Access Compliance Report

Public Rights-of-Way

(Curb Ramps)

Intersection ID: 2835	Main Street: CARDINAL_POINT_RD	Cross Street: RED_CLOVER_LN	Location: W
ADA ID: B255FC2F2AC2	Ramp Type: Perp	Initial Pass/Fail: Pass	Overall Compliance: No
Severity Score: 15			
Codes/Mitigation Info/Possible Solution		Field Measurements/Component Compliance

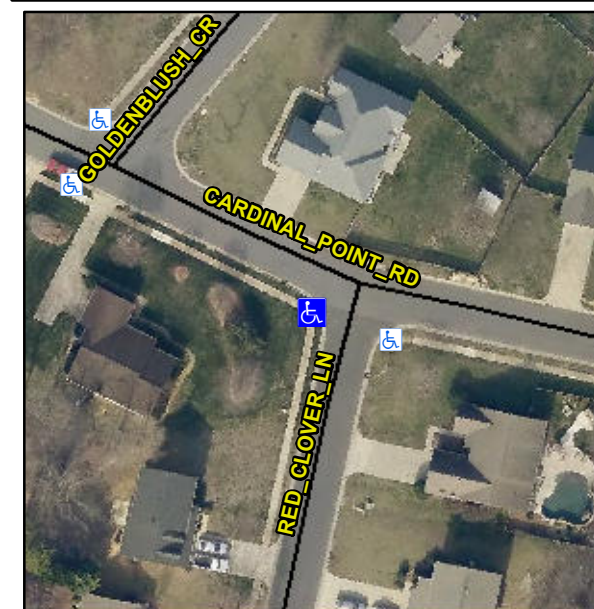
**R304.2.1, R304.2.2-Perp, R304.3.2-
Para, R305.2, R302.7.2**

**Remove & Replace Entire Ramp.
Grind Gutter Lip.**
